Letter of Response

**RE: 35-41 Wilfred Barrett Dr, THE ENTRANCE NORTH NSW 2261
Development Application DA/308/2011**

We refer to the comments from the JRPP meeting dated 17 May 2012. We have since tested a few design options in response to issues raised by the JRPP and we have had a meeting with Wyong Council on 20th June 2012 to discuss the best design outcome. This letter accompanies the revised architectural plans Issue E.

Test design option of Lakefront elevation showing site without fill

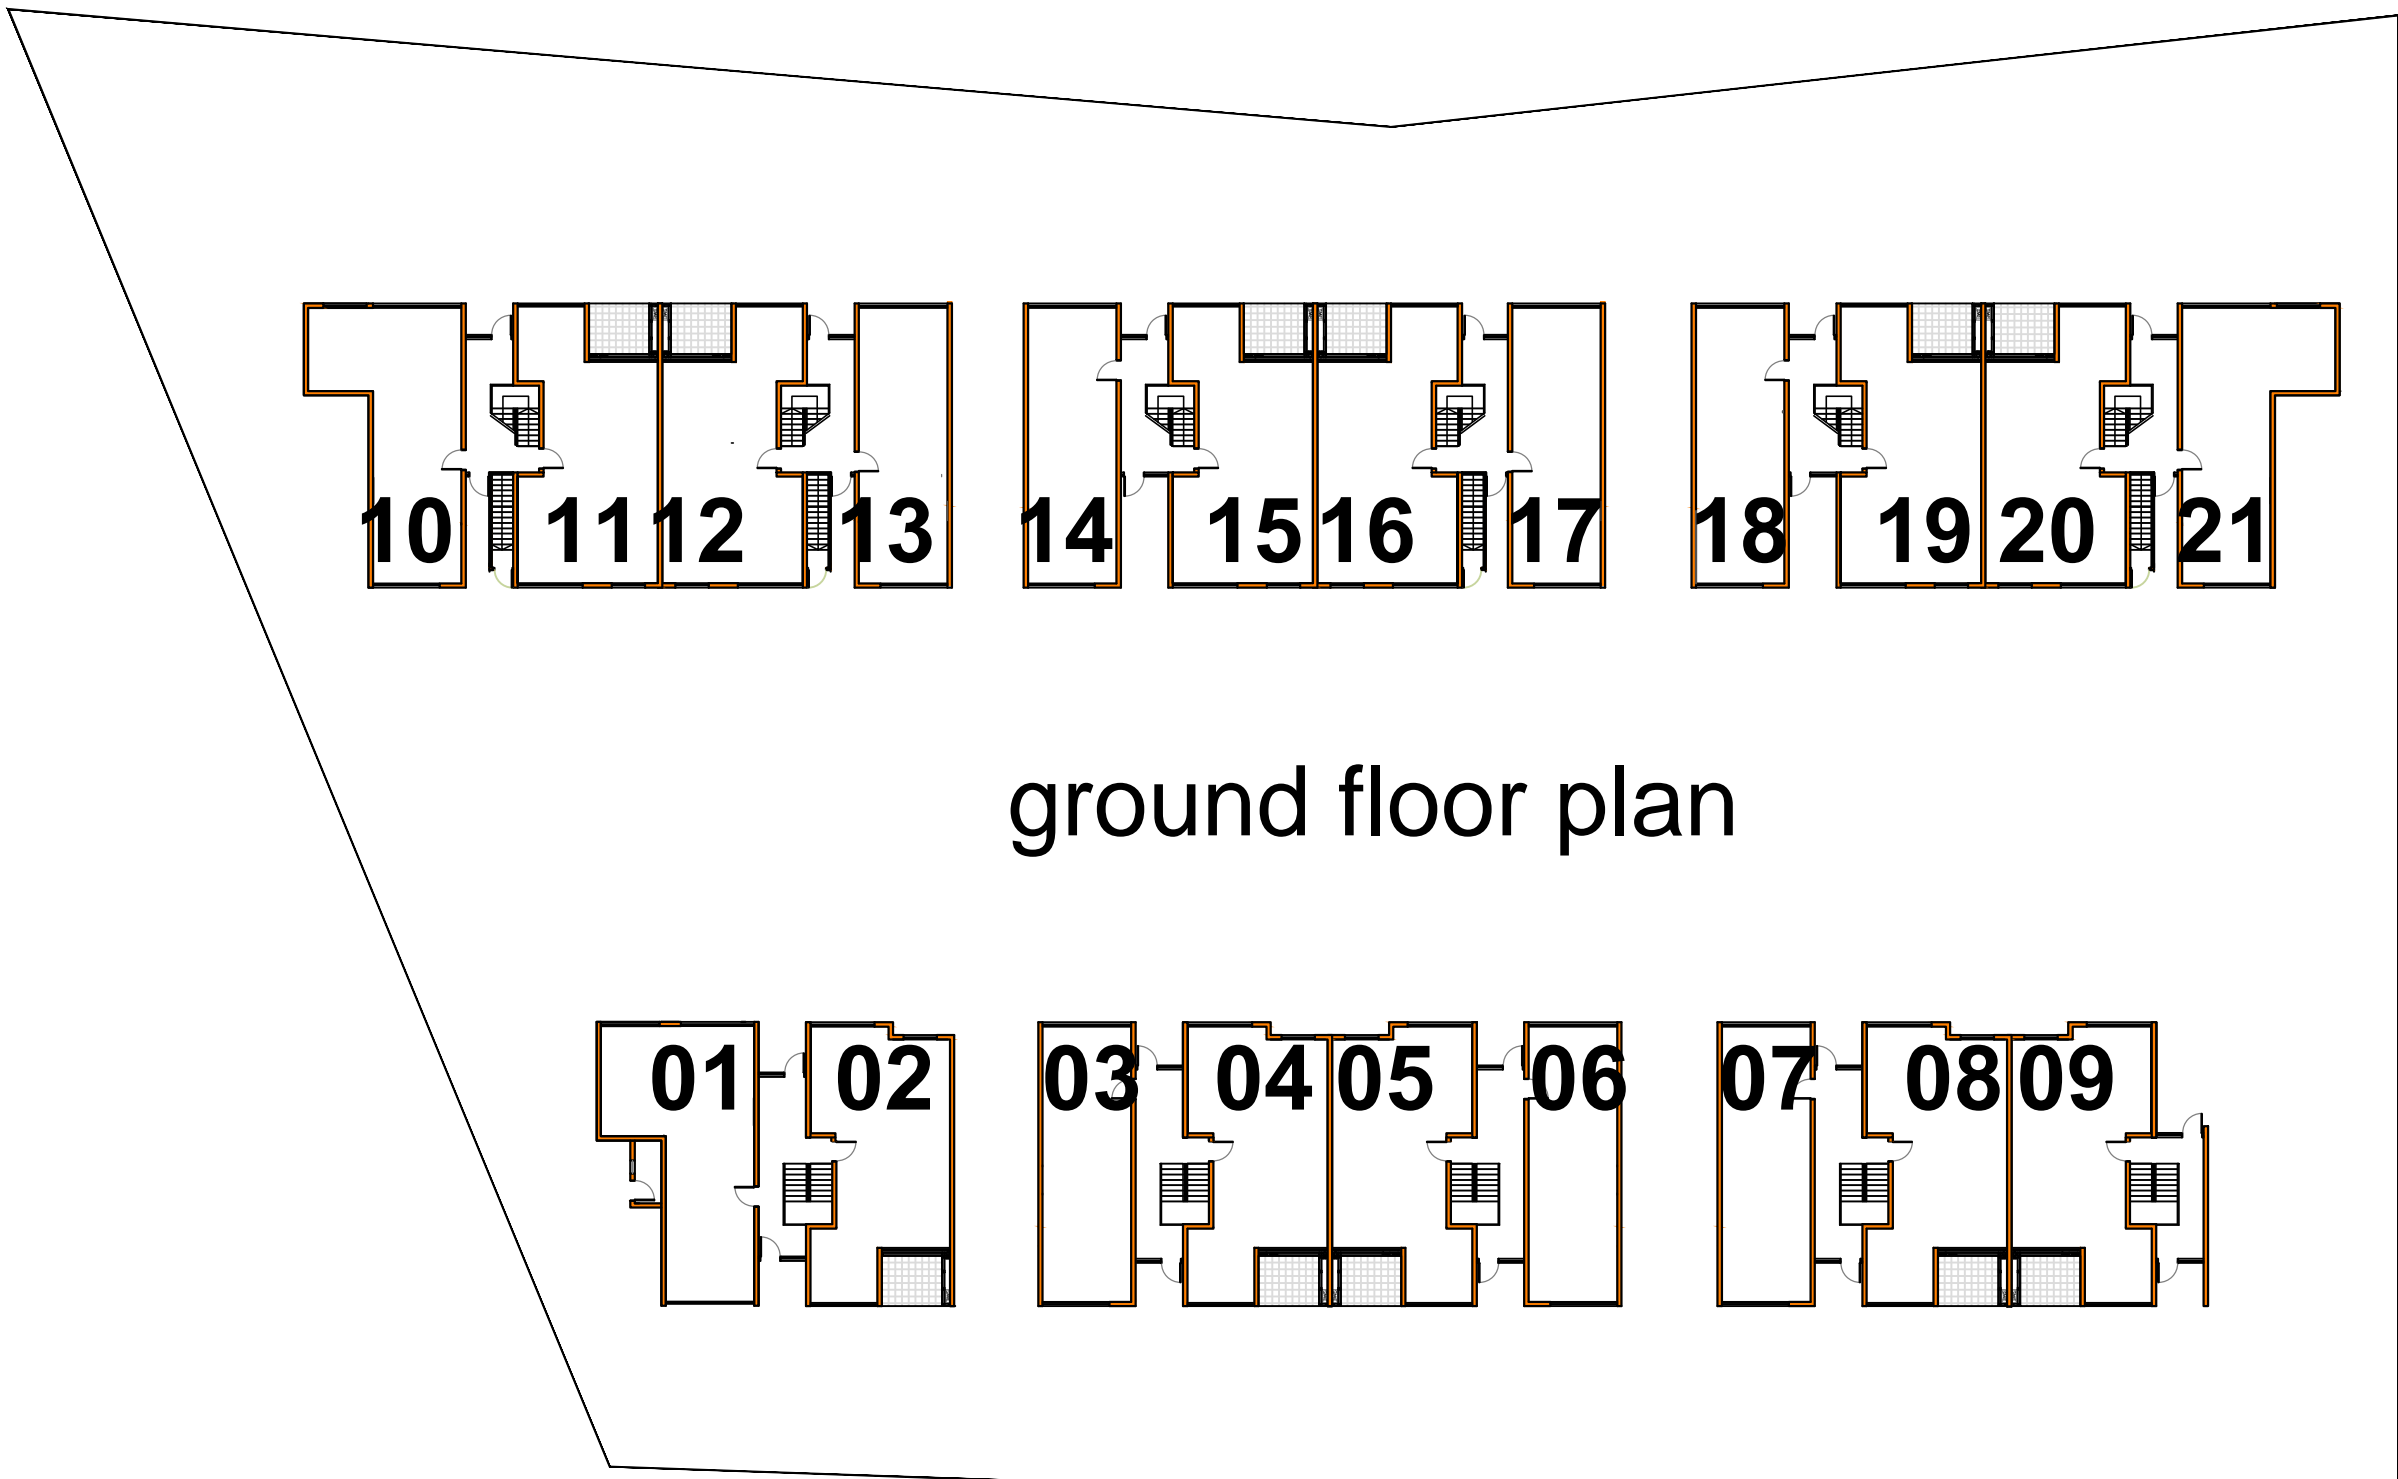
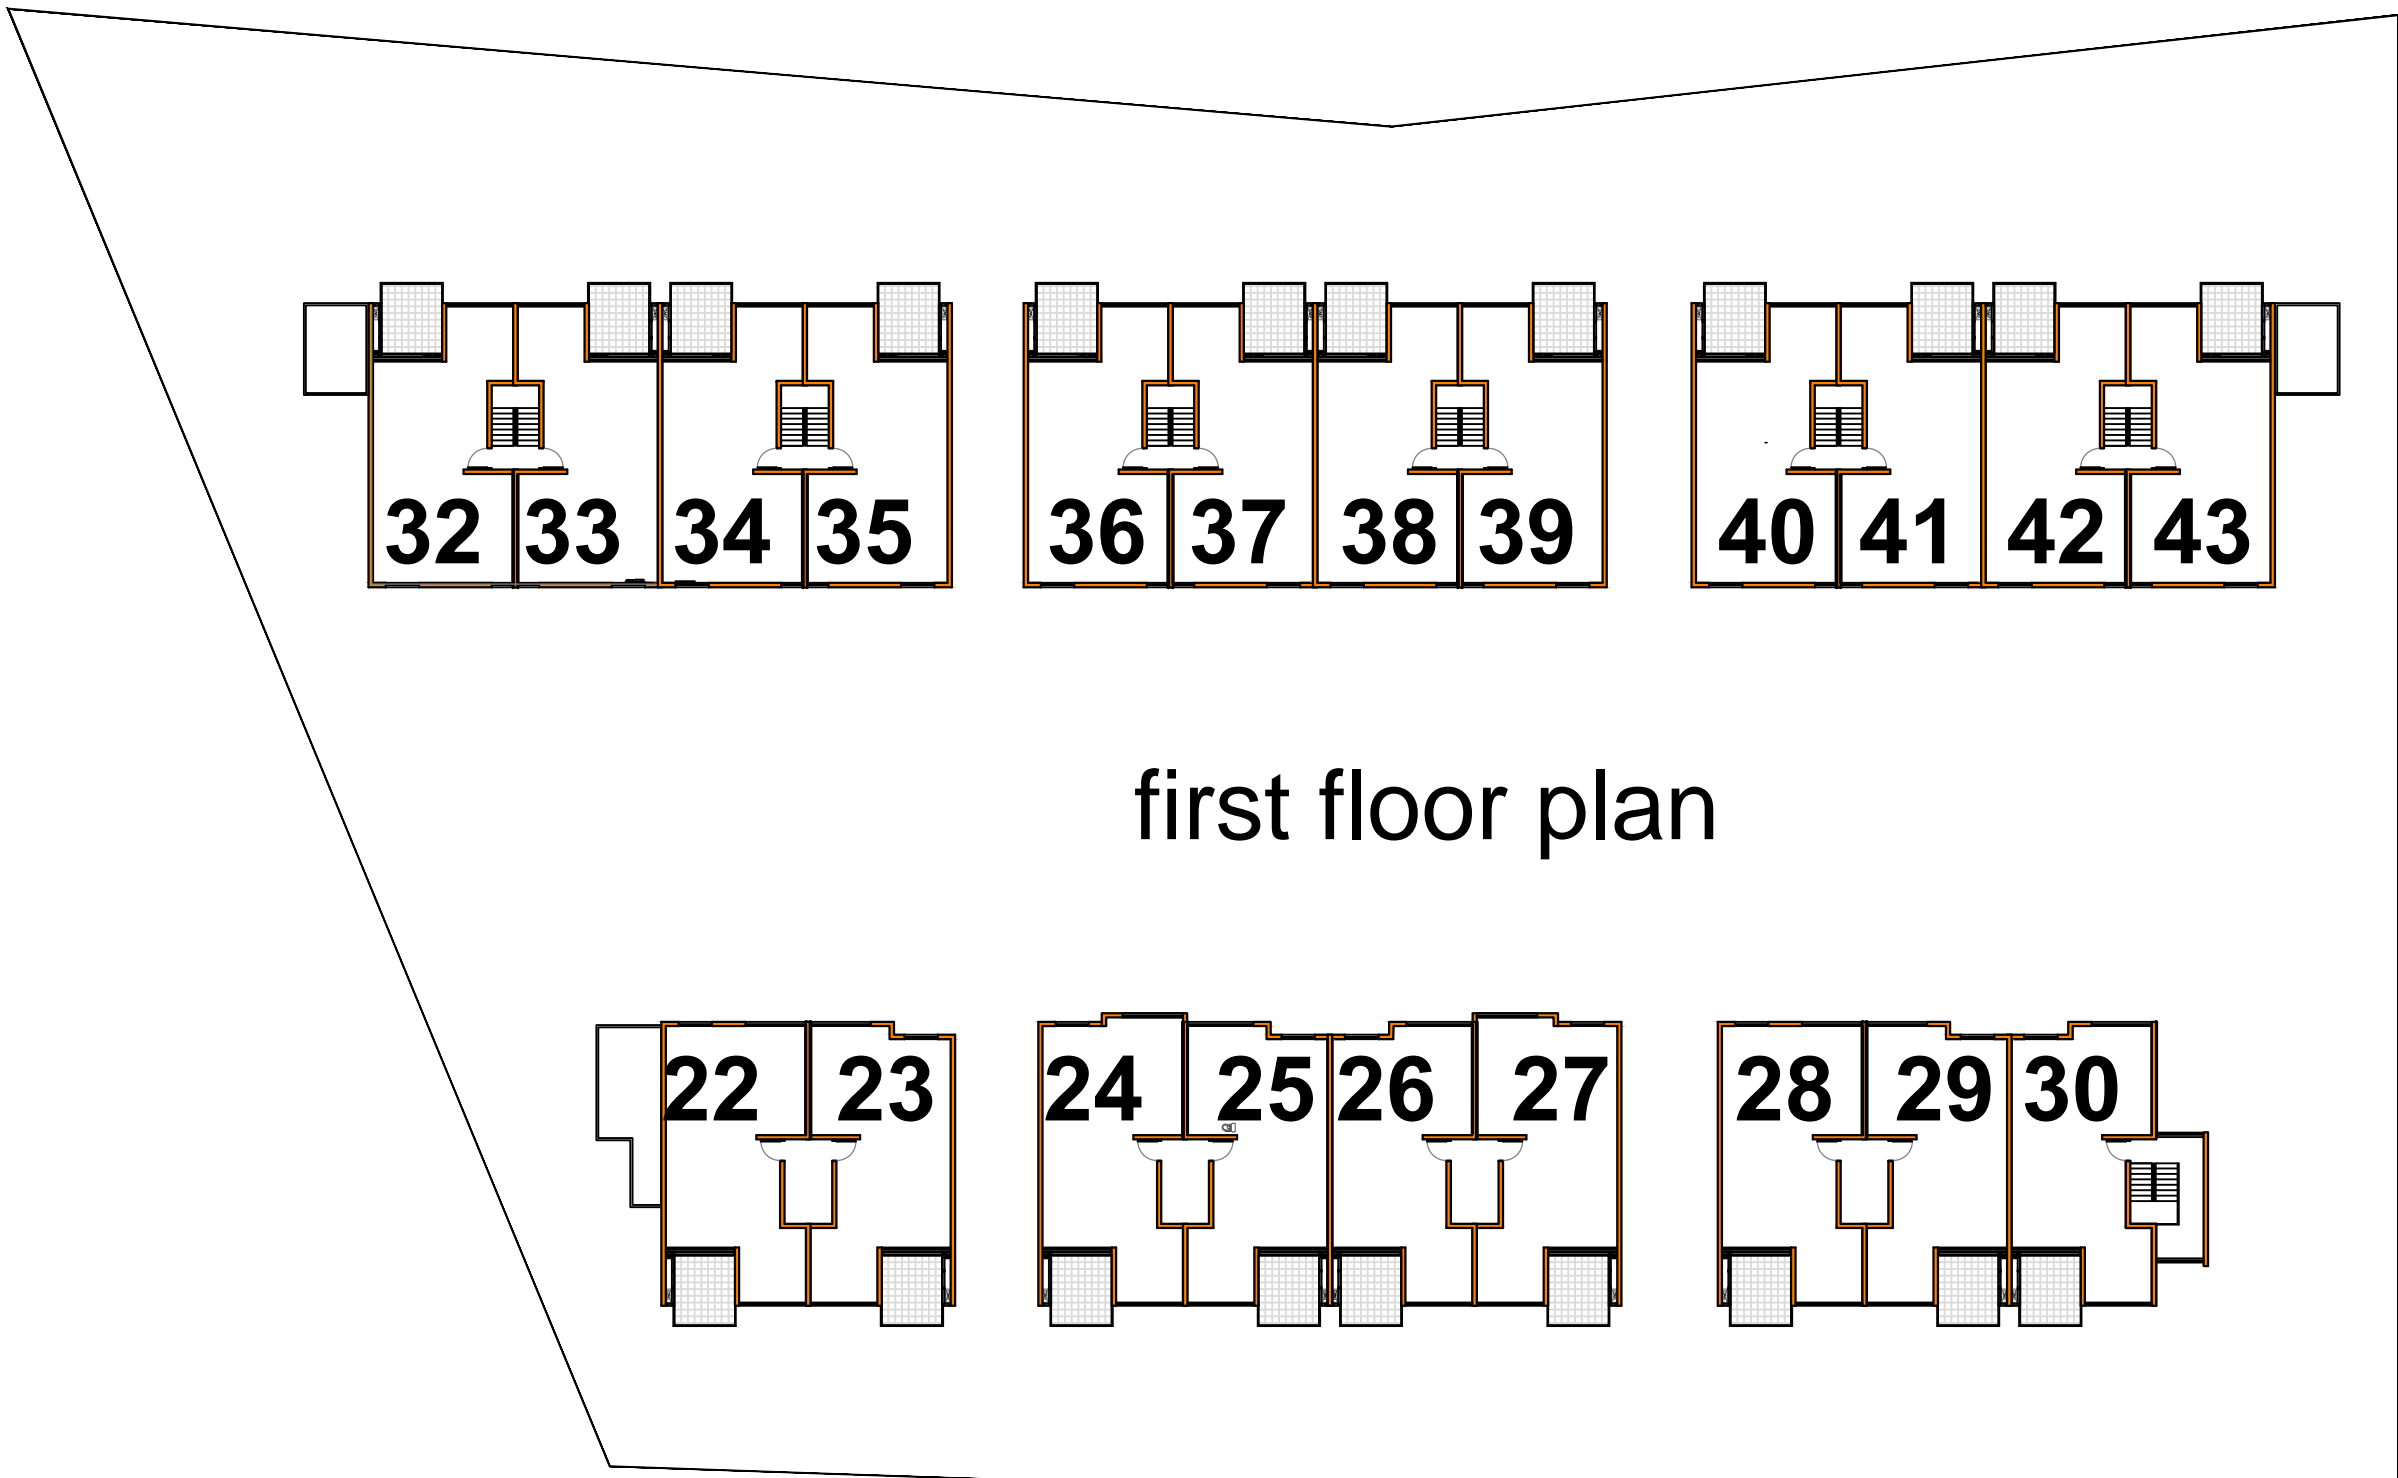
In response to Mr Grant's comments, we have tested the option of removing the fill along the lake side:

Removal of fill will result in a significant level difference between the living spaces of the lakefront units and their courtyards (approximately 1.8m). The living space will be disconnected from its private outdoor space. Such design proposal will not only be of poor amenity for future residents living in those lakefront units, it will also have a very negative impact on the economic value of these units. (*refer appendix 1*)

Moreover, the lakefront common area will not be easily accessible for people in wheelchairs due to the level difference. The ease of access from ground level to the common open space along the lake will be greatly affected. The common open space will become disconnected with the rest of the development, and not likely to be frequent by residents. The valuable lake front area will eventually become a non active space.

Based on our design analysis, the engineer's expert opinion and our meeting with council, we strongly believe that the benefits of having fill in the development prevails. Therefore, we have maintained our initial proposal of having fill along the lakefront area to enhance living amenity to future residents. This will not only maintain the direct relationship between the living areas and the private open space, it will also encourage regular use of the common open space and will improve passive surveillance along the site.
